MOTORCYCLE DOCTOR LLC

50mm Higher Oil Level

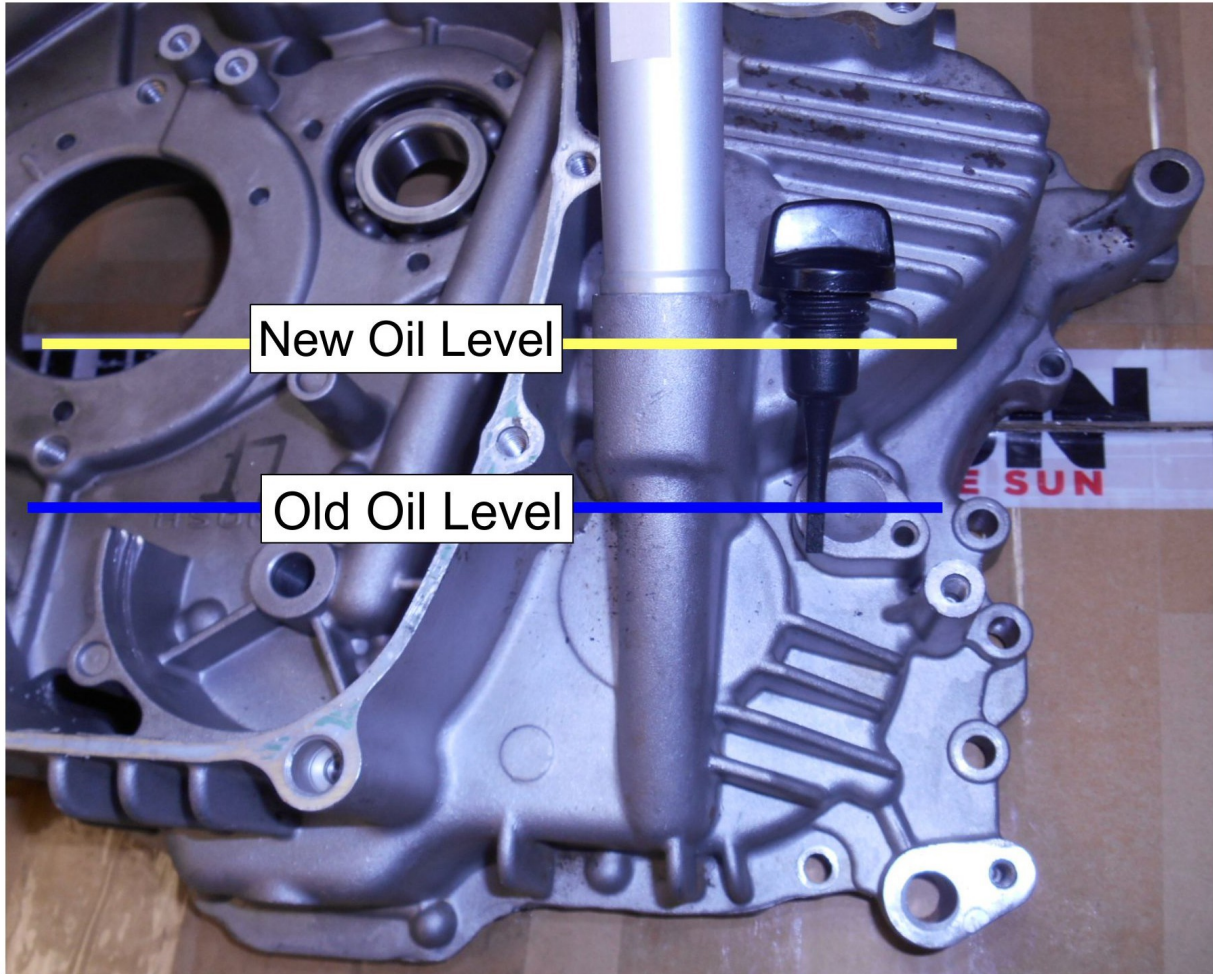
This shows early Black Plastic Dip Stick. Then added Aluminum Tube with Slightly longer metal dip stick. This is Good Upgrade

Now longer Dip Stick lowers oil level back to early year level. This is burning the Wet Shoe Clutch system.

Replace with shorter Dip Stick or cut to shorter length. This will solve many issues.
